SUBMITTAL OF FINAL DANGEROUS AND/OR MIXED WASTE RESEARCH,  
DEVELOPMENT, AND DEMONSTRATION PERMIT (RD&D Permit) FOR THE  
DEMONSTRATION BULK VITRIFICATION SYSTEM (DBVS) IN-CONTAINER  
VITRIFICATION SYSTEM

**IQRPE Design Assessment Report No. DR-013, Rev. 1**

**Demonstration Bulk Vitrification System IQRPE/RCRA  
Design Review Package, RPP-24544, Revision D**

**Section 2.6, In-Container Vitrification (ICV™) System  
(90 Percent Design)**

**Drawing F-145579-35-A-0100, Rev P**

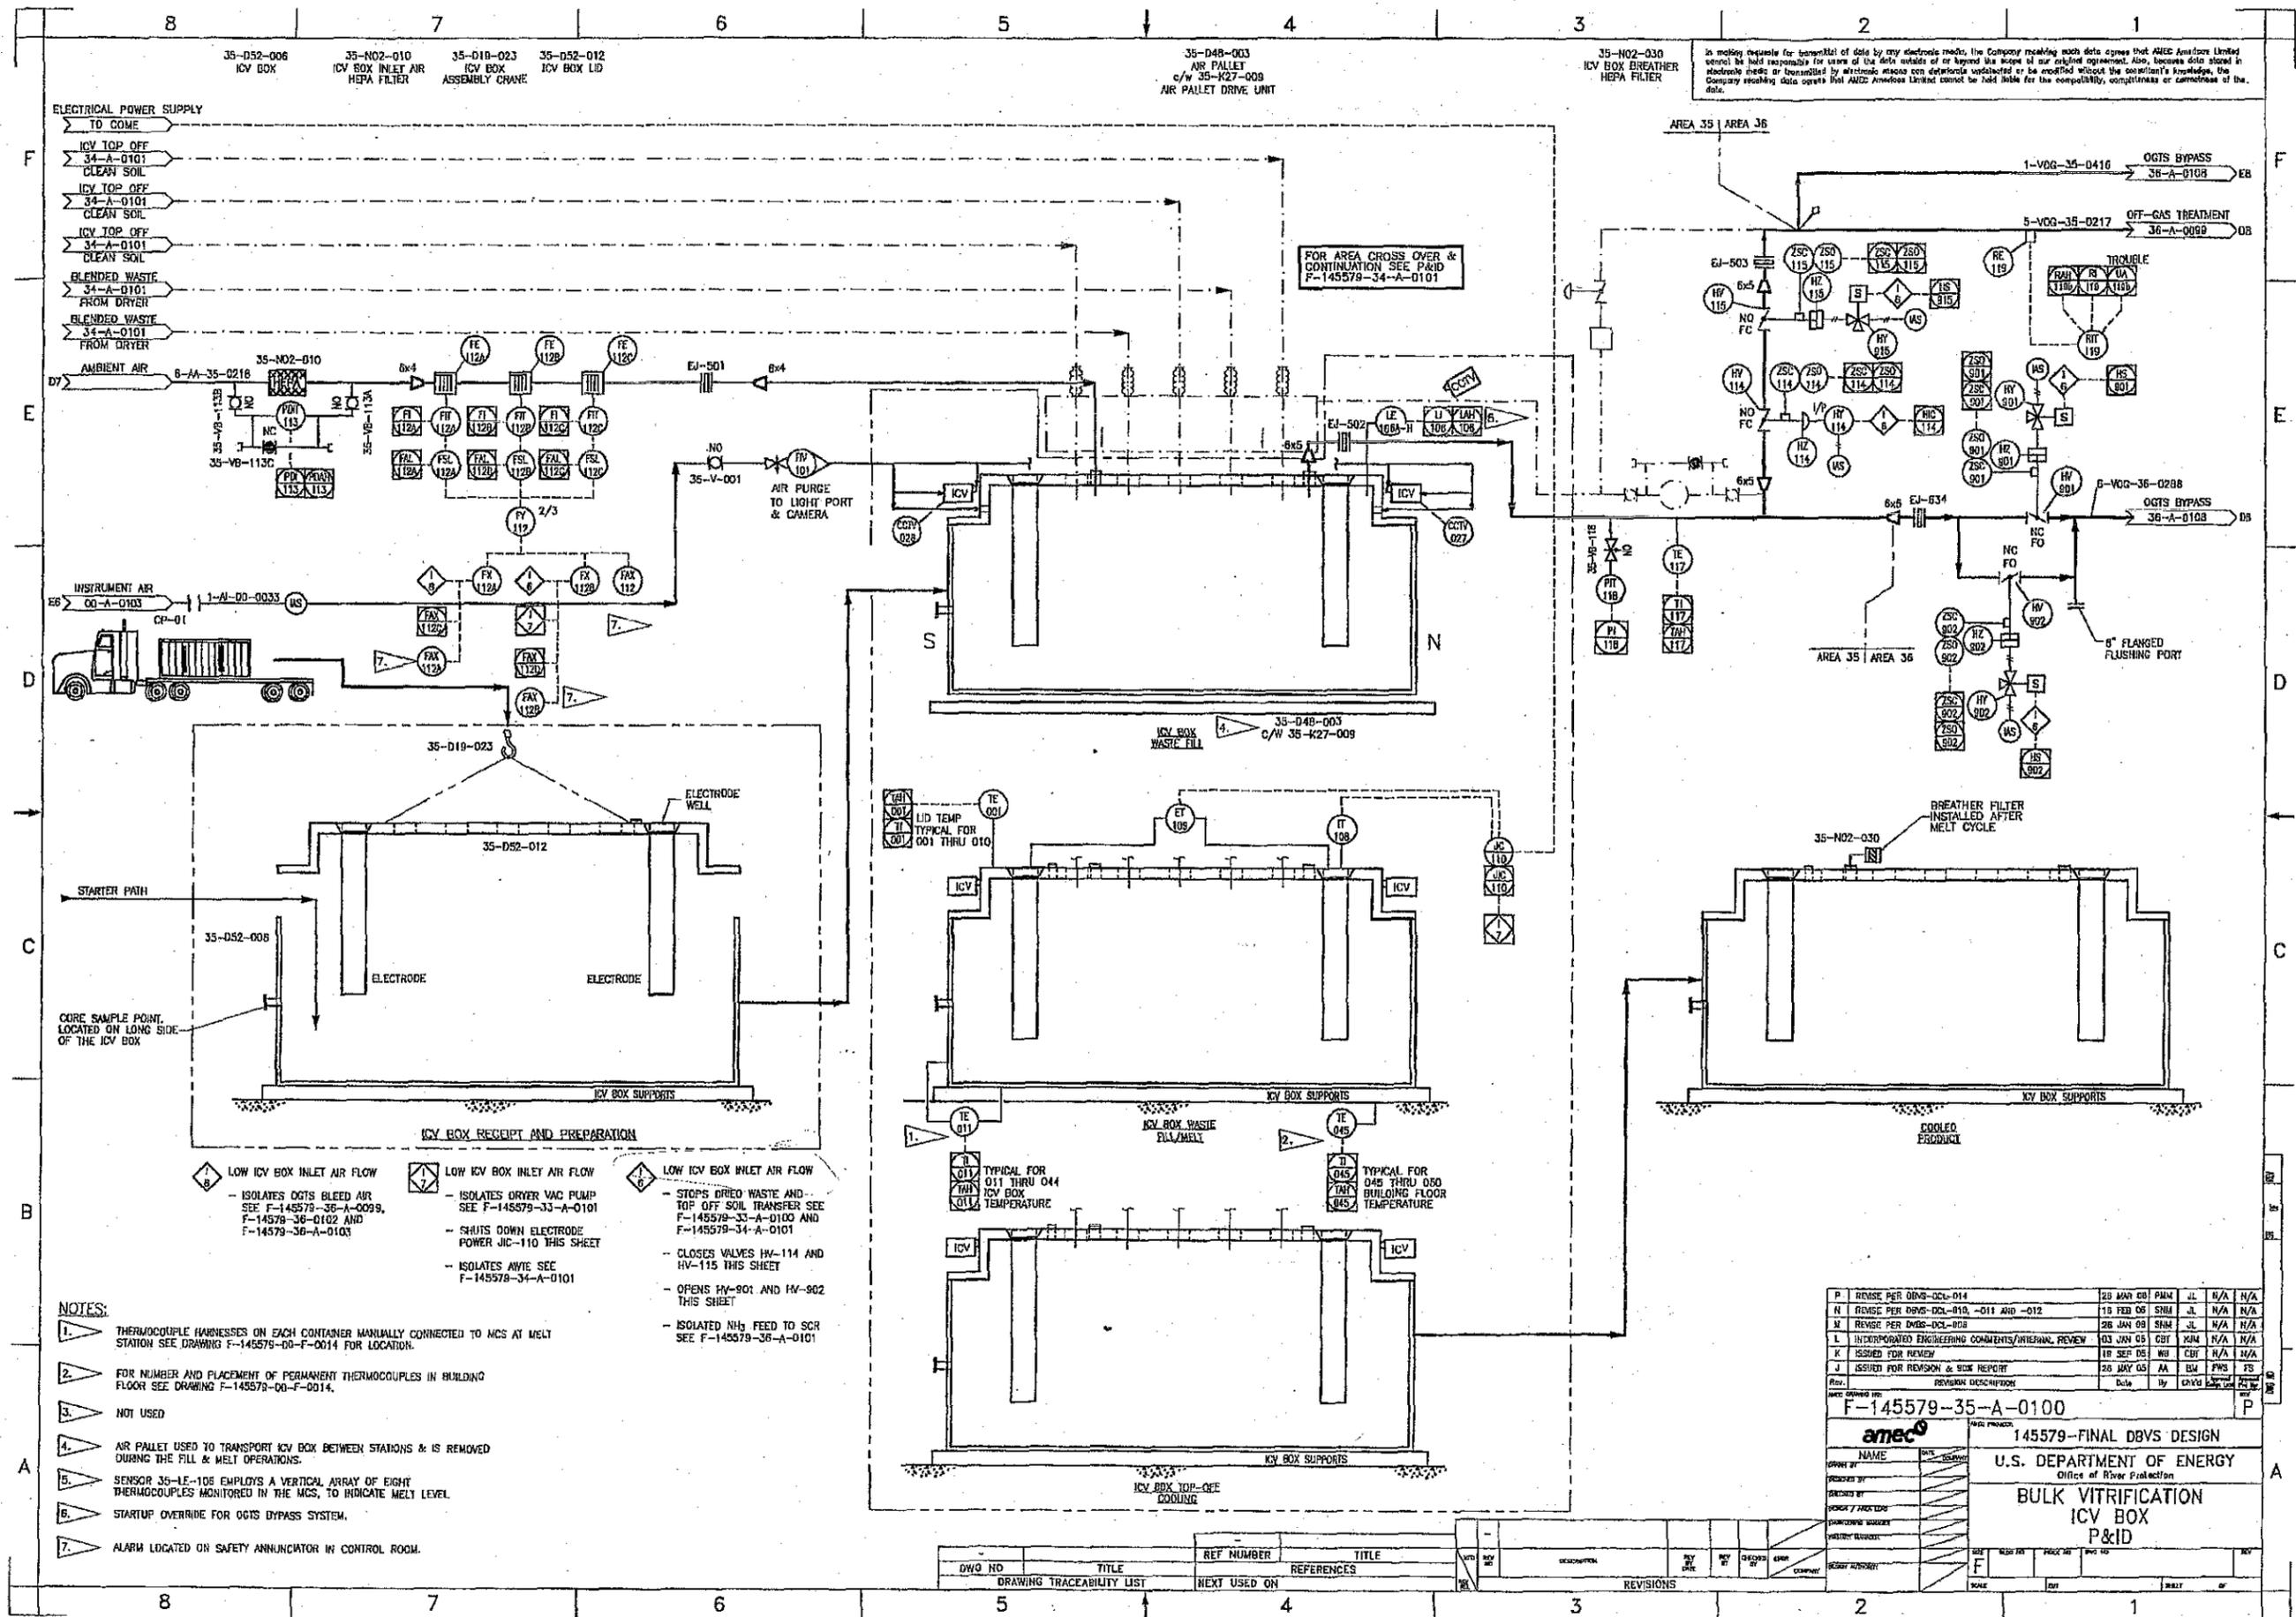
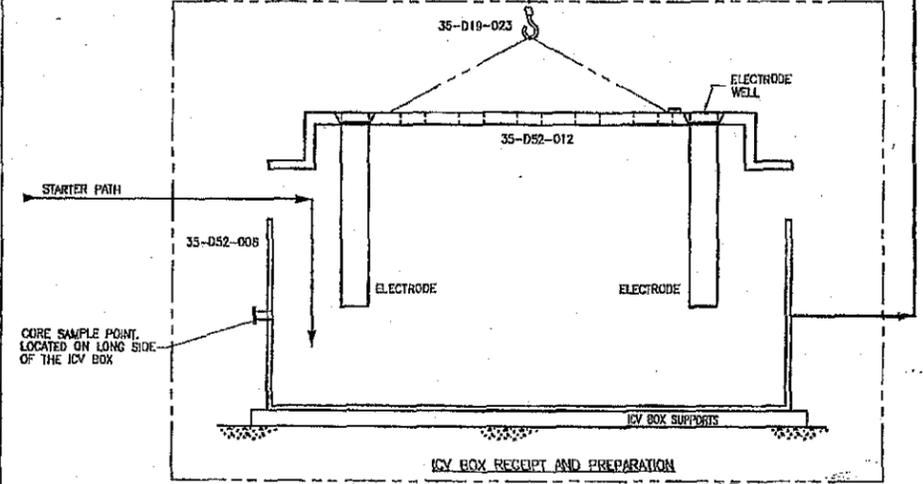
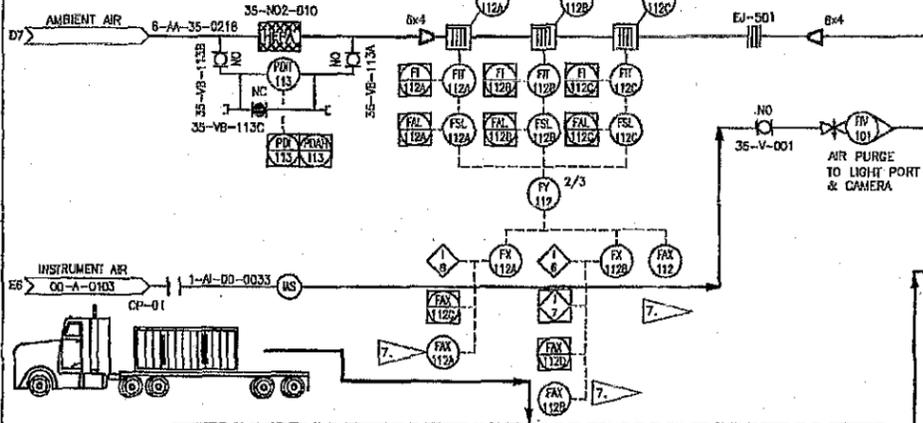
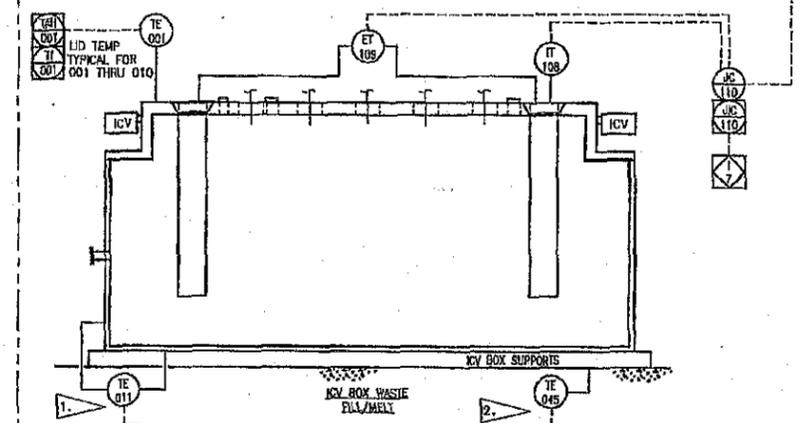
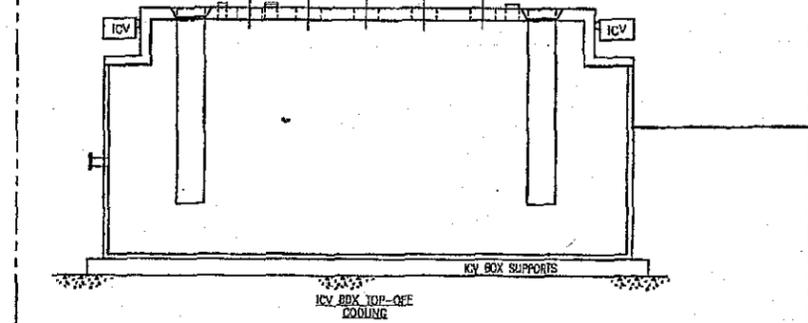
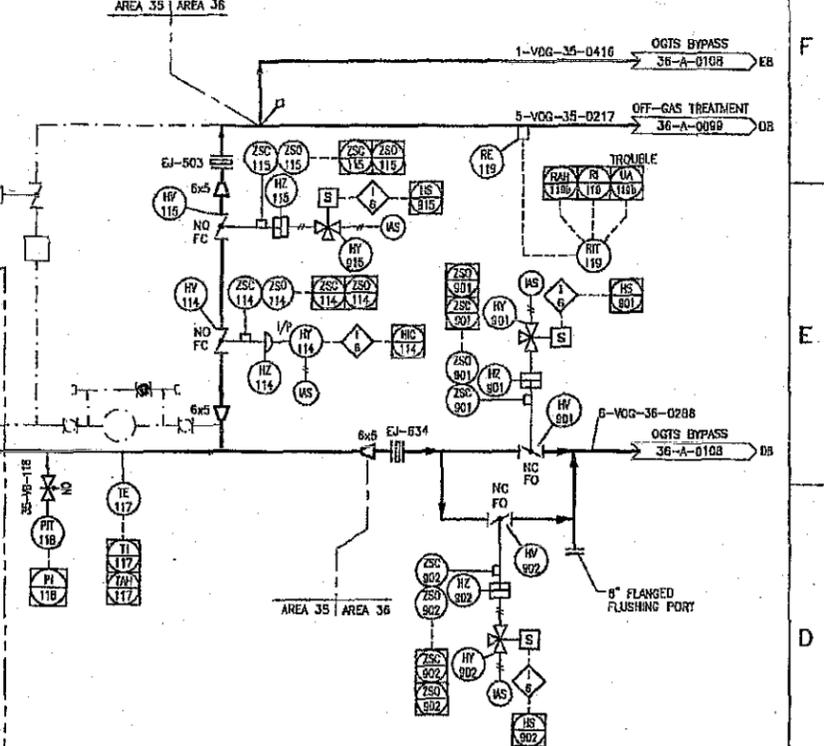
Revise P&ID F-145579-35-A-0100 in accordance with P&ID review comments below:
